Response to Highways England Deadline 7 Documents 8.80, 8.83, 8.84, 8.86 & 8.89:

8.80 Applicant's Comments on any Additional Information or Submissions Received by Deadline 6

Figure 7.4: DS AADT 24hr flows

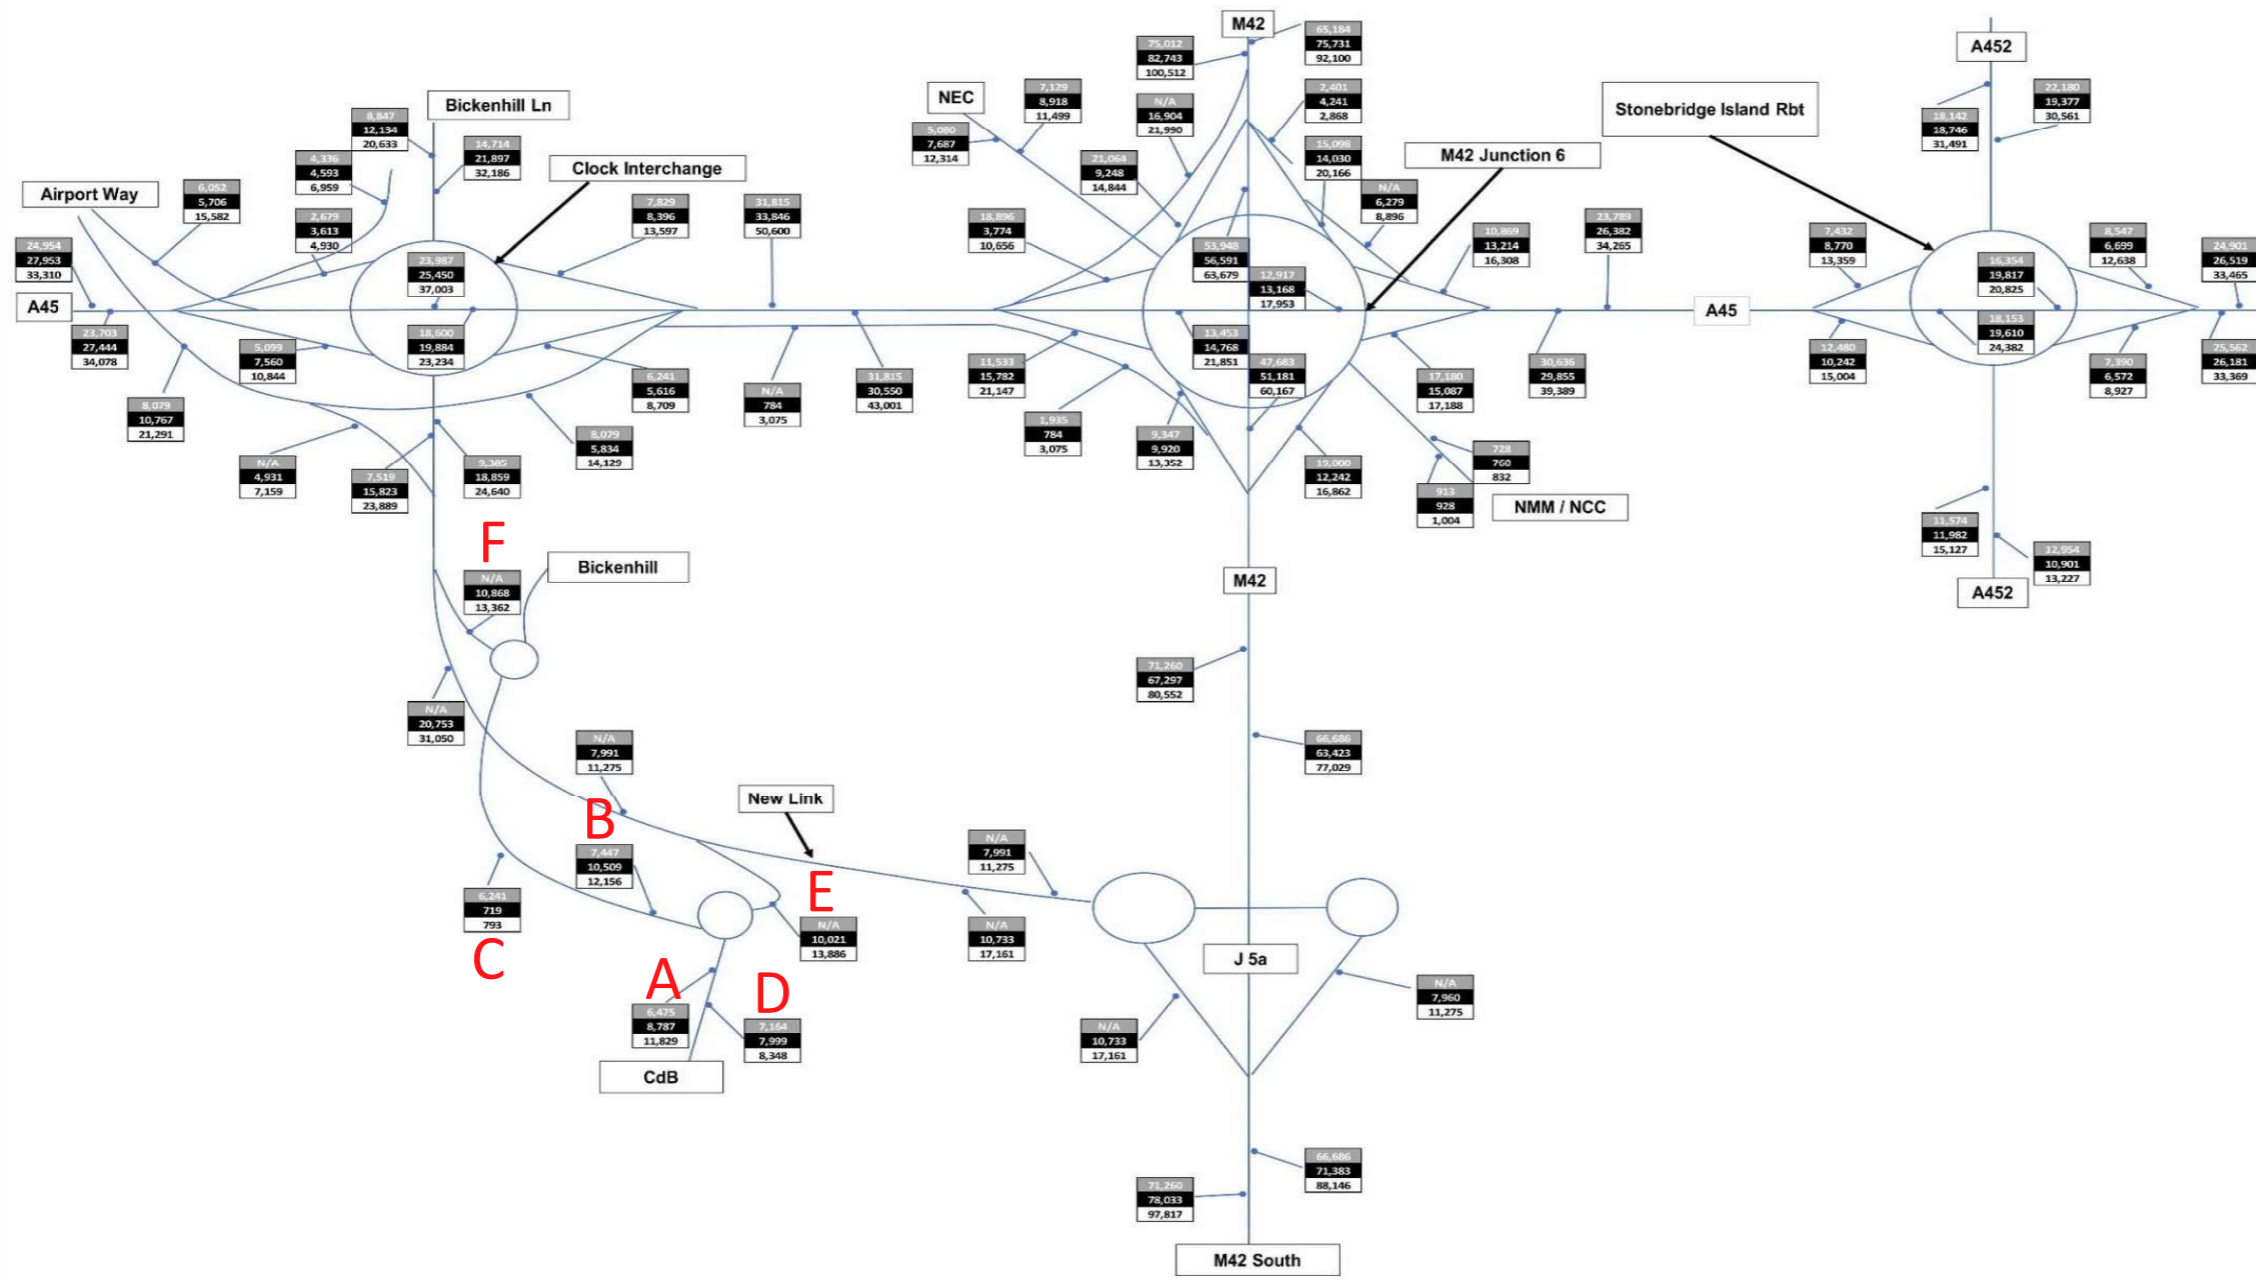
Figure 7.4 - Do-Something AADT 24hr Flows (2016 Base – 2021 – 2041)

- In 2016, 7447 vehicles will travel southbound on the Realigned Catherine de Barnes Lane from Bickenhill Roundabout to Barber’s Coppice Roundabout but in 2041 that figure rises by 63 per cent to 12156 vehicles. That is an increase in southbound Traffic Flow of more than 4700 vehicles

- It appears that a lot of vehicles are going missing on the journey from the north end of Catherine de Barnes Lane to the south end
- There appears to be a false assumption that a lot of southbound traffic is / will be using Shadowbrook Lane

- In 2041, 13362 vehicles take the Diverge Slip from proposed Mainline link to Bickenhill Roundabout but only 12156 will travel southbound on the Realigned Catherine de Barnes Lane from Bickenhill Roundabout.

- On a daily basis 1206 vehicles from the Diverge Slip from proposed Mainline link and 793 vehicles from the northbound Realigned Catherine de Barnes Lane will be going into Bickenhill on a daily basis in 2041. That amounts to 1999 vehicles

- Almost a third of the vehicles that exit Bickenhill Roundabout in 2041 will apparently not reach Hampton Lane Roundabout - 12156 vehicles exit Bickenhill Roundabout but only 8348 vehicles will get to Hampton Lane Roundabout

- In 2016, only 283 vehicles do not travel the full distance from Bickenhill Roundabout to Hampton Lane Roundabout but in 2041 this number has increased by almost 1250 per cent to 3808

Highways England state that in 2041 the daily Traffic Flow from Bickenhill Roundabout to Barber's Coppice Roundabout (step 3 above) will be 12156 (section (B)). The Traffic Flow from Barber's Coppice Roundabout to Hampton Lane Roundabout (step 4 above) is stated as 8348 (section (D)), a difference of 3808. Highways England are forecasting that on a daily basis in 2041, 3808 vehicles that travel south from Bickenhill Roundabout to Barber's Coppice Roundabout are doing so to get onto the Mainline Link road, as they are not continuing to Hampton Lane Roundabout. That amounts to almost a third of all southbound vehicles.

If step 2 of the journey is included, the Traffic Flow for the Diverge Slip from proposed Mainline link to Bickenhill Roundabout (section (F)) is 13362. The Traffic Flow from Barber's Coppice Roundabout to Hampton Lane Roundabout (step 4 above) is stated as 8348 (section (D)), the difference is 5014 vehicles.

Are Highways England suggesting that on a daily basis in 2041, 5014 vehicles will exit the Mainline Link road but will not continue to Hampton Lane Roundabout?

Highways England state that in 2041 the daily Traffic Flow from Hampton Lane Roundabout to Barber’s Coppice Roundabout (step 1 above) will be 11829 (section (A)). The Traffic Flow from Barber’s Coppice Roundabout onto the Merge Slip to the proposed Mainline Link road (step 2 above) is stated as 13886 (section (E)), a difference of -2057.

Some of the vehicles that exit Hampton Lane Roundabout and travel onto Barber’s Coppice Roundabout will continue northbound to Bickenhill Roundabout and for this the Traffic Flow is 793 (section (C)). As such, the difference between the Traffic Flow from Barber’s Coppice Roundabout onto the Merge Slip to the proposed Mainline Link road is $((11829 - 793) - 13866) = -2830$.

Are we to assume that on a daily basis 978 vehicles will vanish when they get to Barber’s Coppice Roundabout?

Figure 7.5: 2021 and 2041 peak hour differences (DS-DM)

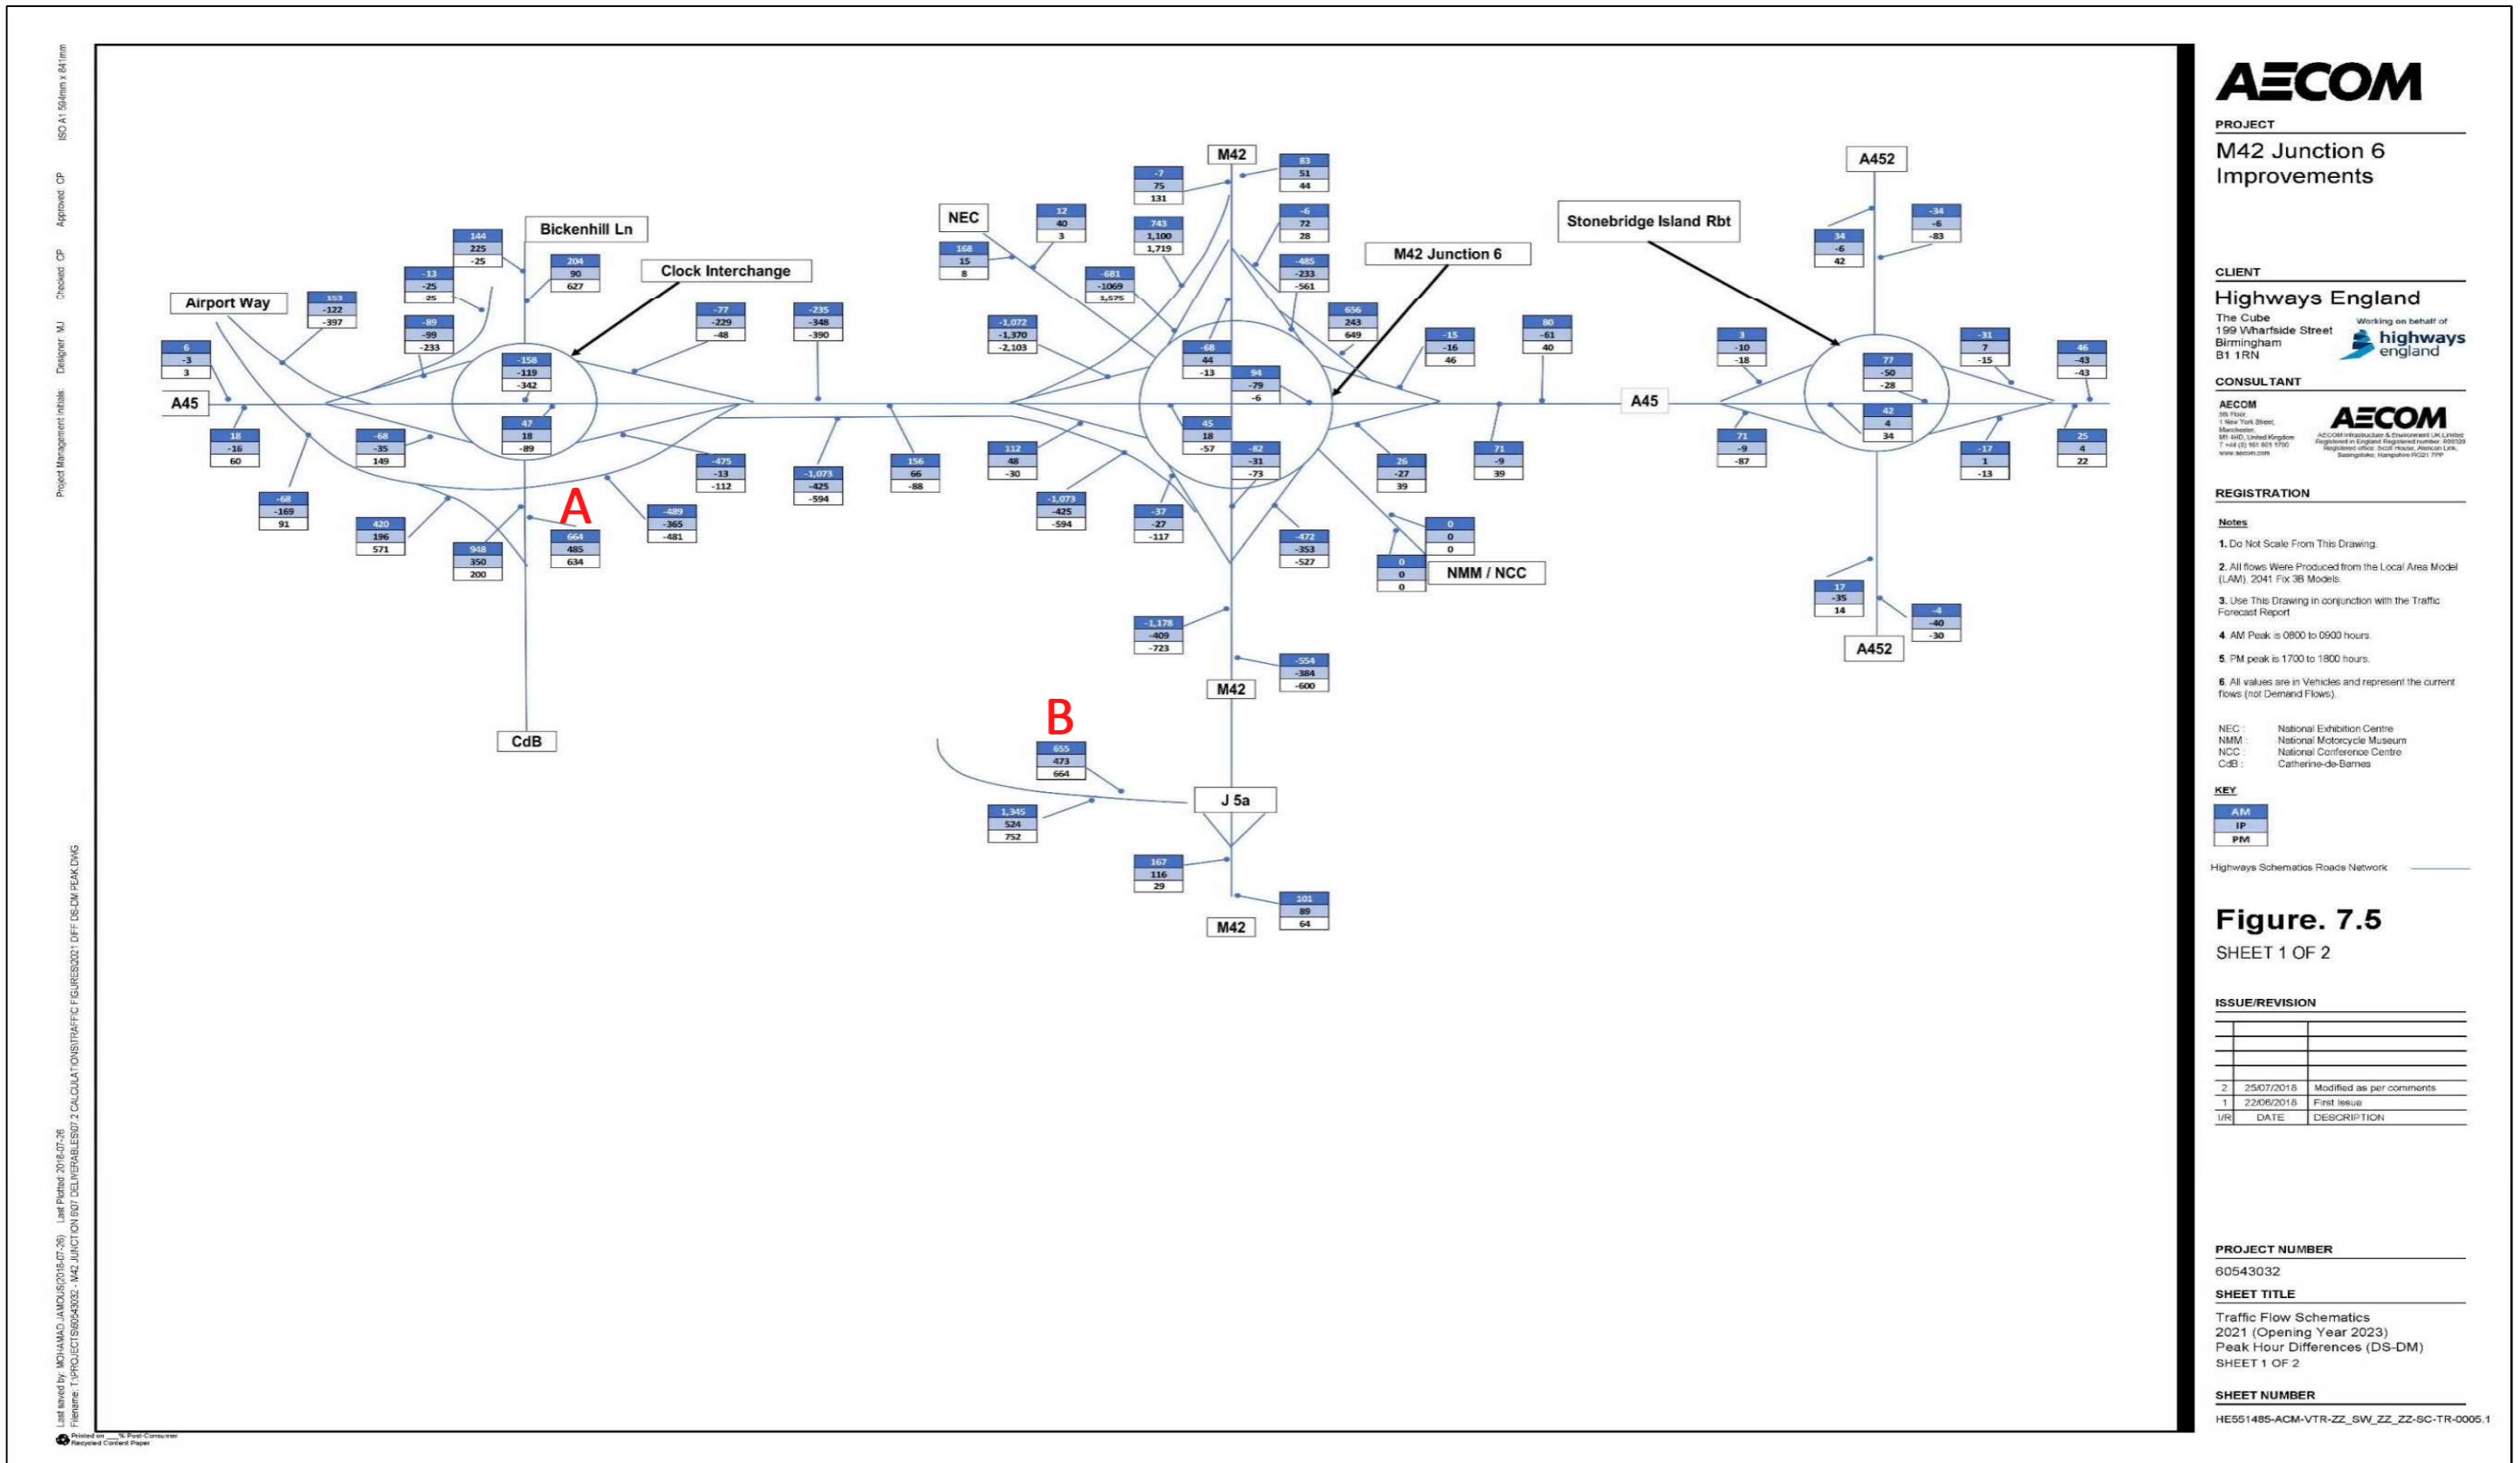
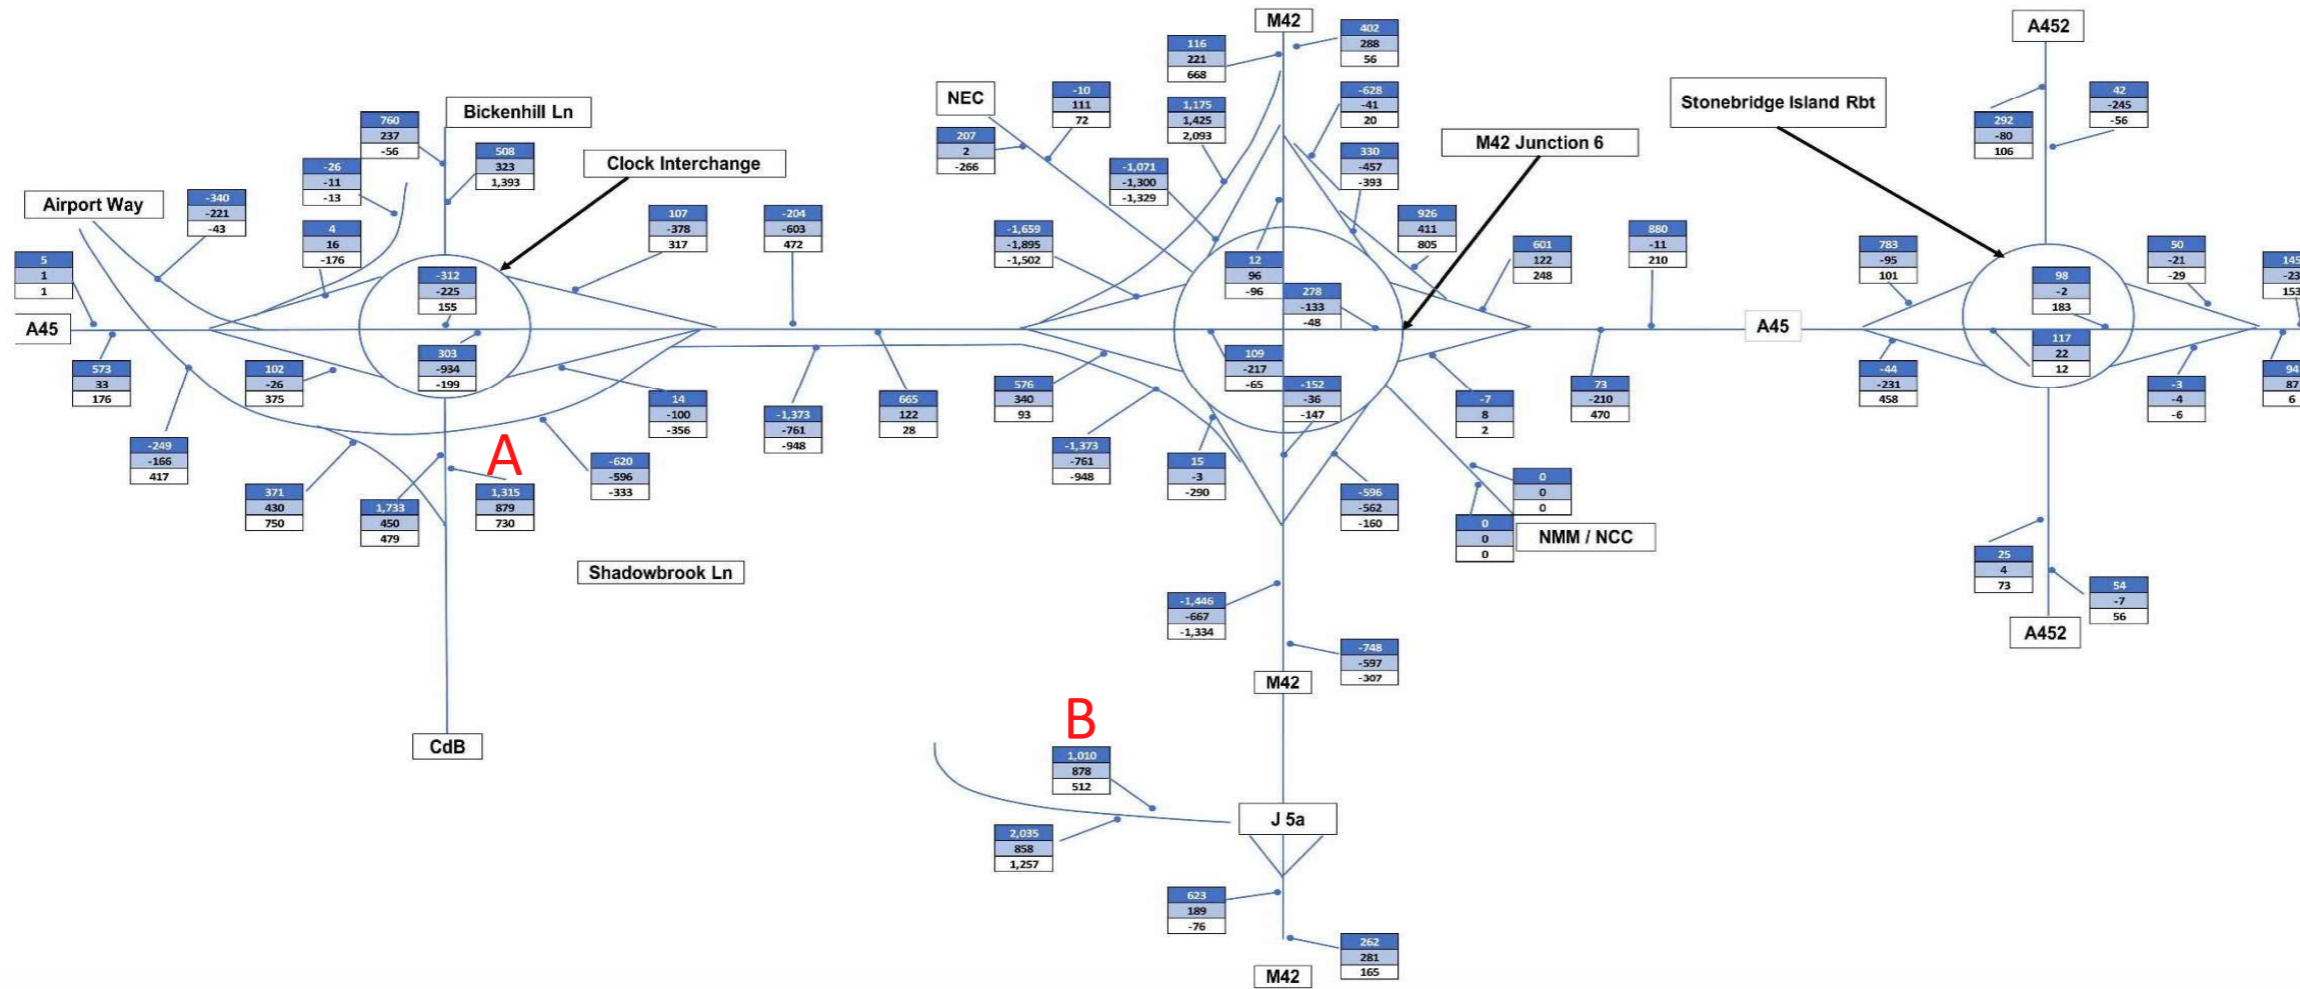
Figure 7.5 – 2021 (Opening Year 2023) Peak Hour Differences (DS-DM) & 2041 (Design Year 2038) Peak Hour Differences (DS-DM)

- Unfortunately Figure 7.5 omits the works between Clock Interchange and Hampton Lane Roundabout but does include Junction 5a
- In 2021, during AM hours, 664 more vehicles will exit Clock Interchange traveling south and 655 of these vehicles will continue onto the Mainline Link road. It appears there will only be an increase of 9 vehicles using the Realigned Catherine de Barnes Lane in 2021 during AM hours
- In 2021, during PM hours, 634 more vehicles will exit Clock Interchange traveling south but 664 vehicles will continue onto the Mainline Link road. Where have the extra 30 vehicles come from?
- In 2041, during AM hours, 1315 more vehicles will exit Clock Interchange traveling south and 1010 of these vehicles will continue onto the Mainline Link road. It appears there will be an increase of 305 vehicles using the Realigned Catherine de Barnes Lane in 2041 during AM hours
